TEXAS BOARD OF HEALTH

Responses to Recommendations and Suggestions in U.S. Nuclear Regulatory Commission IMPEP Report

RE: License No. L04463 and SSD TX0246D103S

Copy of Reply to SSD TX0246D103S

DRAWING No. CS031600401

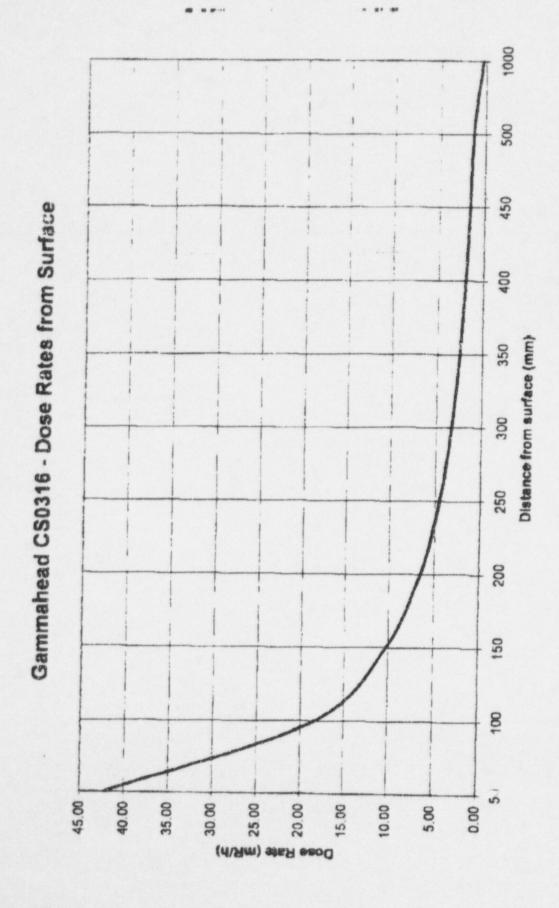
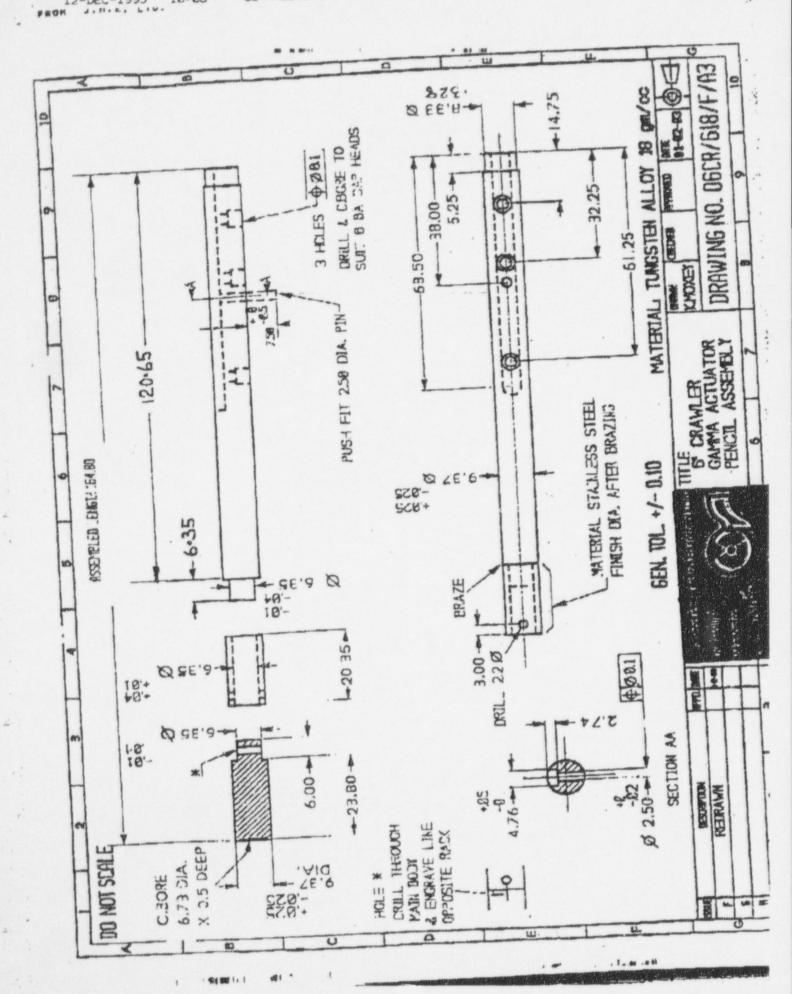
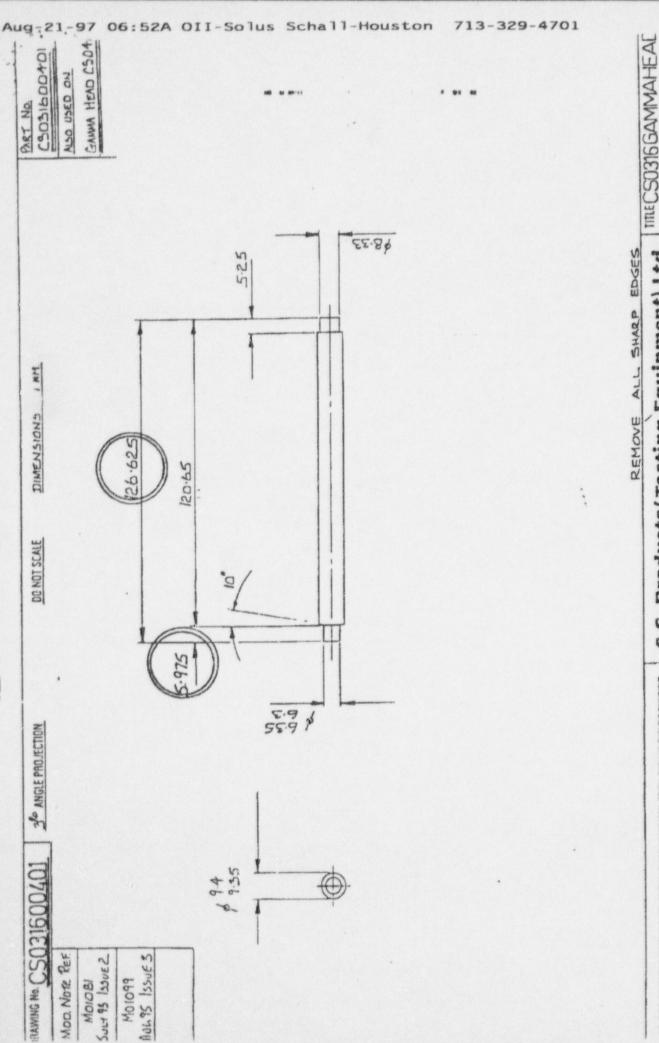
- 5. Two questions arose concerning drawings referenced in your application and the letter dated September 12, 1995. Drawing CS0316004A references a part no. CS031600401 and a part no. CS031600403. We only received a copy of CS031600401 and did not receive a copy of CS031600403. The drawing of CS031600401 does not resemble that part referenced in CS0316004A. Please explain.
- 6. Finally, it is our understanding that you will only use or lease this device when it is attached to a crawler. Is this understanding correct? Will there ever be a case where the gamma head will be distributed to another licensee without being attached to a crawler? Will another licensee be allowed to remove the gamma head from your crawler?

- 7. The applicant has provided new drawings that explain the assembly process of the actuator pencil.
- 8. The applicant has supplied new drawings that clarify the adequacy of the design.

- We are enclosing a copy of CS031600403, this should explain the assembly of the actuator pencil in it's entirety.
 To further assist we are also including a copy of drawing 06CR/618/F/A3.
- 6. We will only lease or use this device when attached to a crawler. We will not ever use, or allow to be used, this device without a crawler. All the equipment owned by Oceaneering International, Inc., Solus Schall Division is used and maintained solely by ourselves and no other license is allowed to access our equipment.
